TEMPORARY REVISION

TR-MÄM-20-405

Change from CHT to Coolant Temperature Measurement

This Temporary Revision TR-MÄM-20-405 is approved in conjunction with the Mandatory Design Change Advisory MÄM 20-405 and is valid in conjunction with the latest revision of the DV 20 Airplane Flight Manual until this Temporary Revision has been incorporated into the Airplane Flight Manual.

6.5. EQUIPMENT LIST

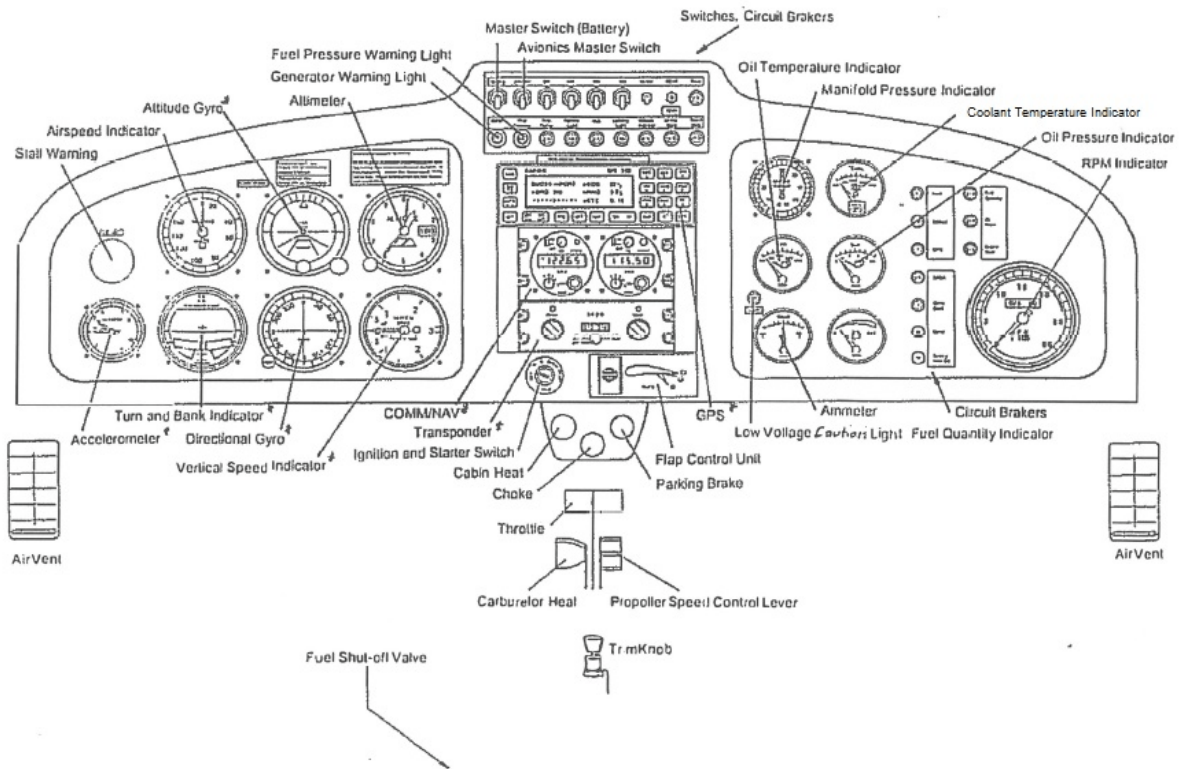
Item 16 is amended to read:

Seq. No.:	Part Description, Manufacturer, Type	Serial No.:	Inst.	Mass [kg] (lbs)	Arm [m] (in)
16	if MÄM 20-405 is installed: Coolant Temperature Indicator TC1-9031-10-01_01			0.14 (0.31)	-0.390 (-15.35)
	if MÄM 20-405 is NOT installed: Cylinder Head Temperature Indicator HOAC 16160			0.14 (0.31)	-0.390 (-15.35)

7.11. ELECTRICAL SYSTEMS

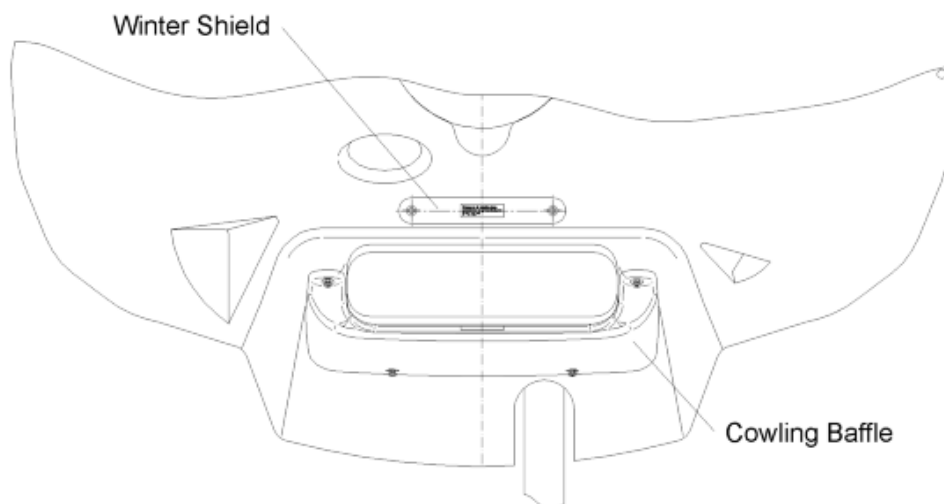
The following paragraph is added:

if MÄM 20-405 is installed:

The instruments for temperature, oil pressure, and fuel quantity are connected in series with the respective sensors. The electrical resistance of a sensor changes with the measurable variable, which causes the power to the instrument and consequently the needle deflection to change. Oil pressure indicator, coolant temperature indicator and fuel pressure warning light are supplied with power through one circuit breaker. Oil temperature indicator and fuel quantity indicator are also protected together by one circuit breaker.
